Windfarm committee report

Dorenell Wind Farm extension – application under Section 36 of the Electricity Act 1989 for the construction and operation of an extension to the existing windfarm and energy storage facility within the Planning Authority of the Moray Council, of up to 67 (three-bladed) wind turbines, with a range of maximum tip heights from 149.9 m to 250 m and associated infrastructure, and includes Battery Energy Storage (BESS) and associated infrastructure.

ECU00004862 (CNPA ref. 2025/0202/PAC)

Object

Appendix 1 – Dorenell Wind Farm Extension: Proposed windfarm ZTV and Viewpoints

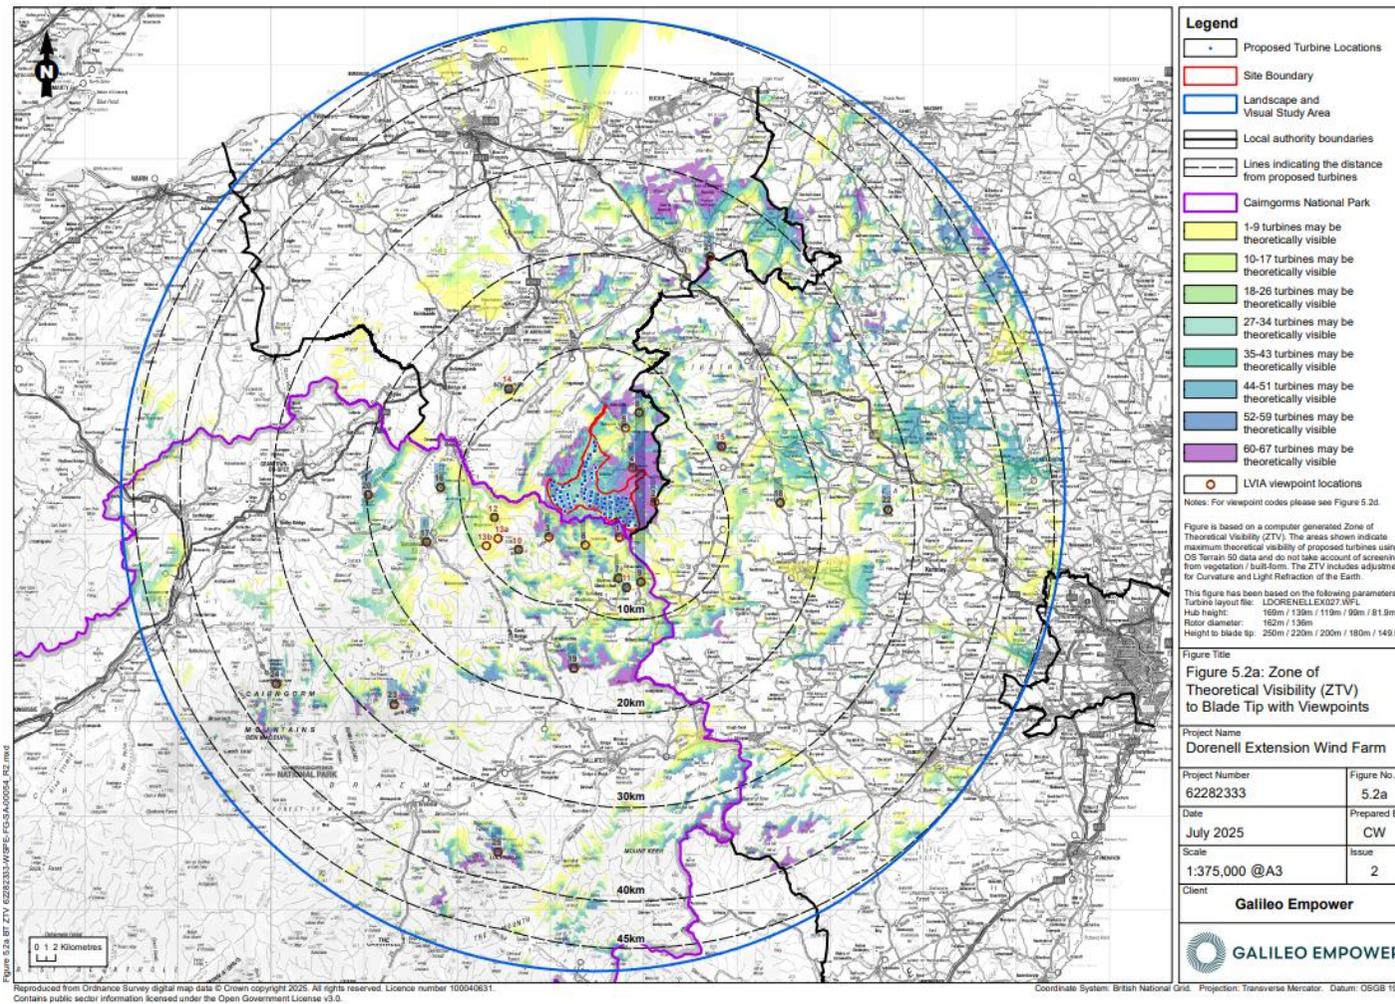
6. Theoretical visibility of the proposed windfarm from within the National Park is shown by the applicant's EIAR figure 5.2a (**Appendix 1**). When considering cumulative visual effects, the applicant's Figure 5.3c Cumulative Zones of Theoretical Visibility (ZTV) (**Appendix 2**) demonstrates the visibility of the proposed windfarm and the existing Dorenell Wind Farm located to the west of the site. The pale blue areas show the increase in visibility of wind turbines with the introduction of the proposed Dorenell Wind Farm extension and the purple areas cumulatively with the existing Dorenell Wind Farm.

7. Visualisations from 17 viewpoints have been provided in the applicant's EIAR to demonstrate the predicted level of visibility that would be had from within / on the boundary of the National Park – refer to **Appendix 1** (Figure 5.2a Blade Tip ZTV with Viewpoints) for the locations:
